Our Ref: E22108/SSJ/UL2

**E22108: FURTHER UPDATE CONCERNING ENVIRONMENTAL WORKS AT SITE OFF CHAPELGATE, SUTTON ST. JAMES**

**Application** H20-0060-24  
**Location** Land adj. Havencombe Chapelgate Sutton St James PE12 0EF  
**Proposal** Details of verification report (Condition 6 of H20-0296-23)

Enc. 'Sketch of Capping Placement Steps' (Drawing E22108/L05)  
SHDC Comments (07/02/24)

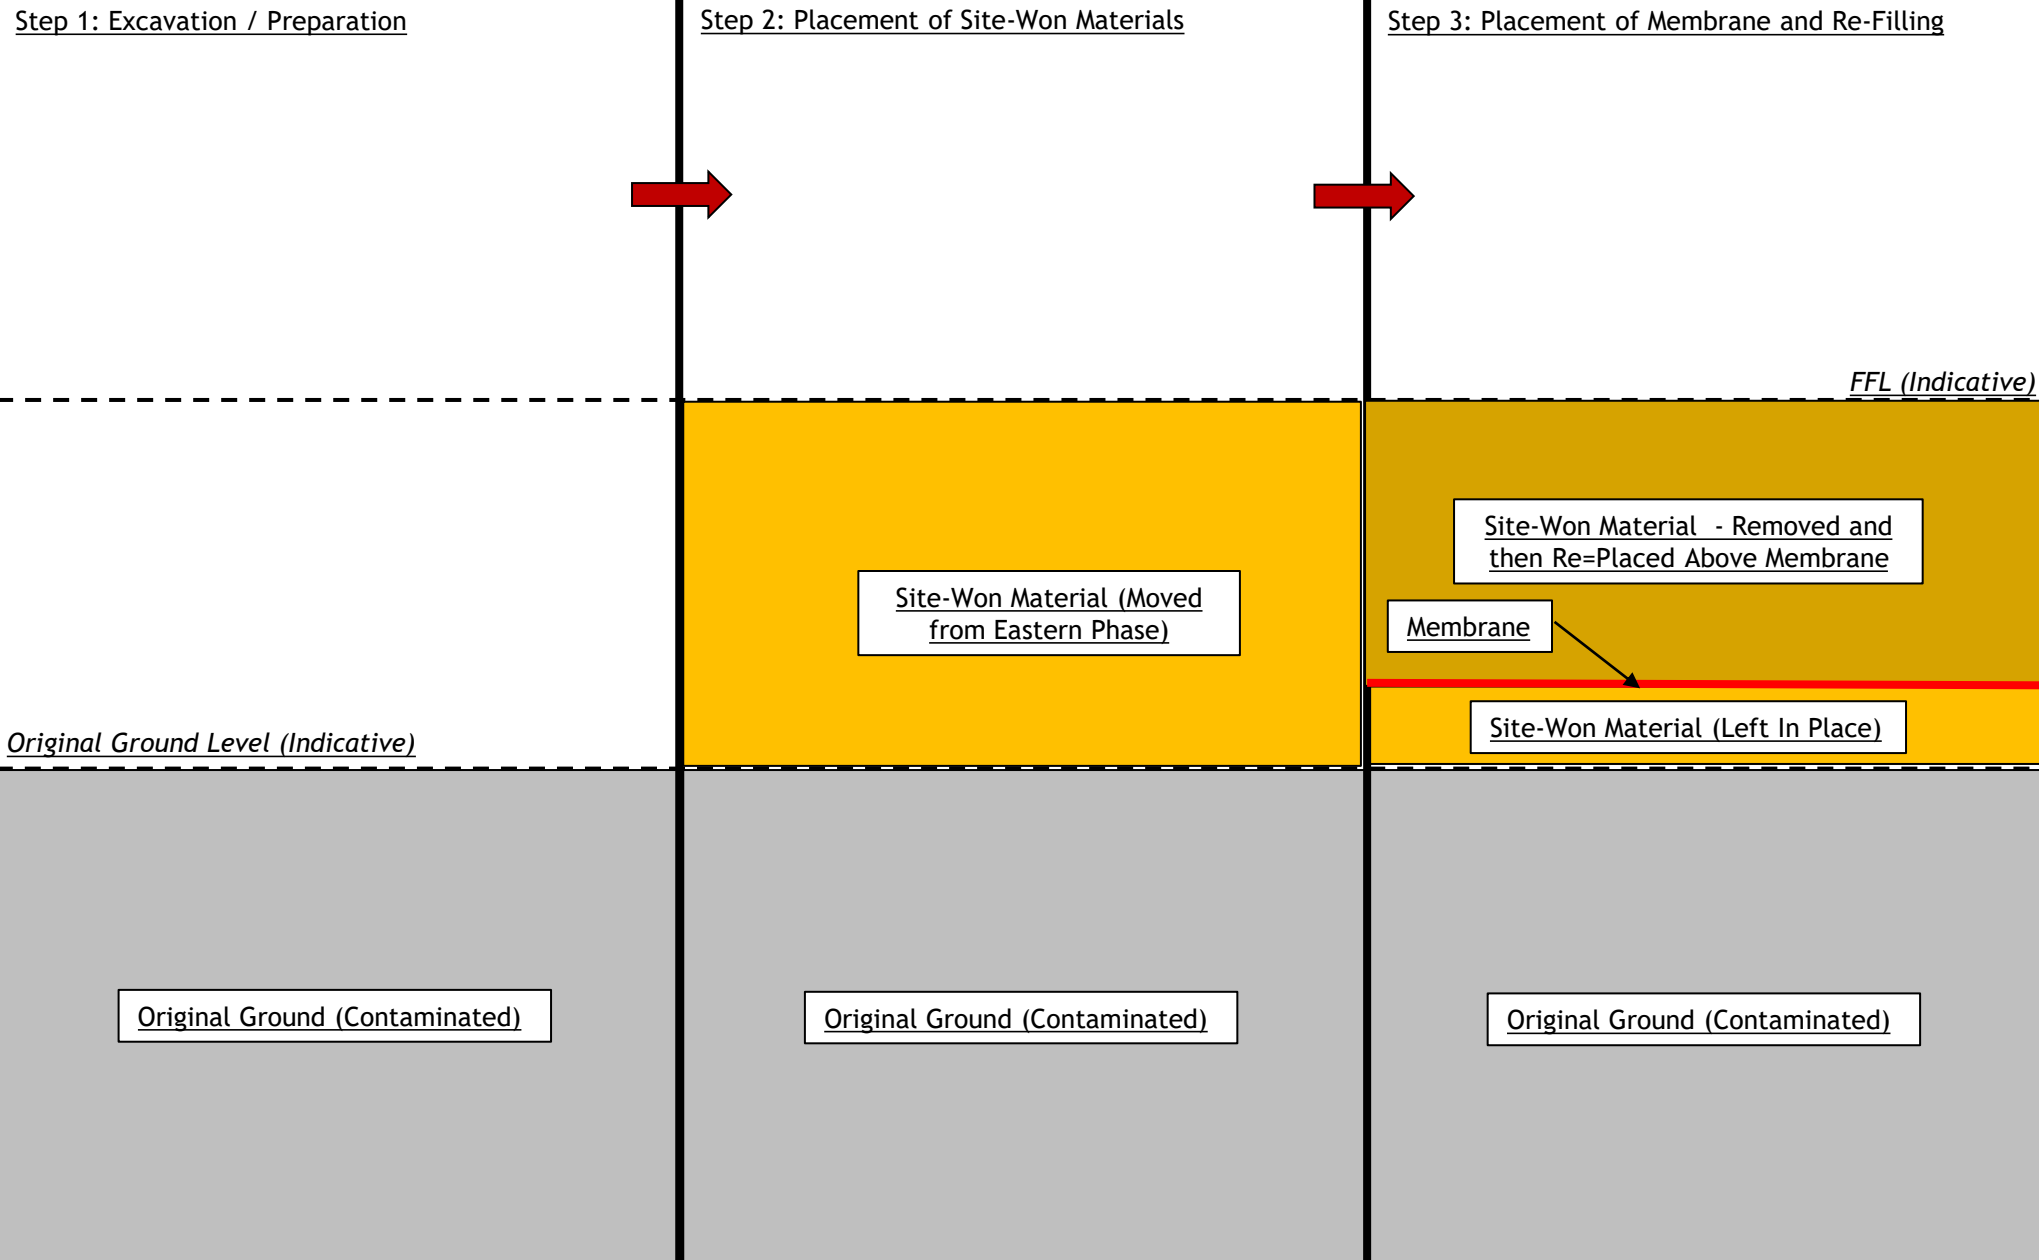
During our meeting today we discussed the membrane and the materials noted in SHDC's latest correspondence ('Material A'). The risk of cross-contamination etc. was discussed and it was confirmed that this is not possible as a sacrificial layer of site-won material (from adjacent phase) remains in place beneath the membrane, which is undisturbed following its original deposition. It is also understood that the materials that are temporarily removed from each plot (i.e. to allow the membrane to be installed) are stored nearby on hardstanding (or similar) and that contact with the underlying 'original ground' is not possible at any time. The enclosed sketch diagram should show these steps, and copies of the sketch and of this letter should be forwarded to SHDC so that their approval for this methodology can be confirmed.

Membrane placement - the letter suggests that unsuitable material has been removed from garden areas and clean fill (Material A) placed. This (Material A) will now be removed, the membrane laid and suitable clean fill will be reinstated to finished levels.

I request that any validation report be very clear on the fate of Material A. As this has been laid directly over the unsuitable soils, there is likely to have been cross contamination. If its proposed to use Material A as the suitable clean fill to make up the final levels, any pre-placement sampling and testing would need to give a high degree of confidence in their suitability for use. A similarly high degree of confidence would need to be provided that the material management was adequately supervised, ideally by the independent consultant. I look forward to receipt of the validation reports in due course., but am not in a position to recommend discharge of condition 6 at this time.

Because a sacrificial layer of site-won materials forms a blanket on top of the original ground, and because this shall be subsequently covered with a membrane and then at least 600mm of clean soils, further testing is not considered necessary at this stage subject to Council and Warranty Provider approval.
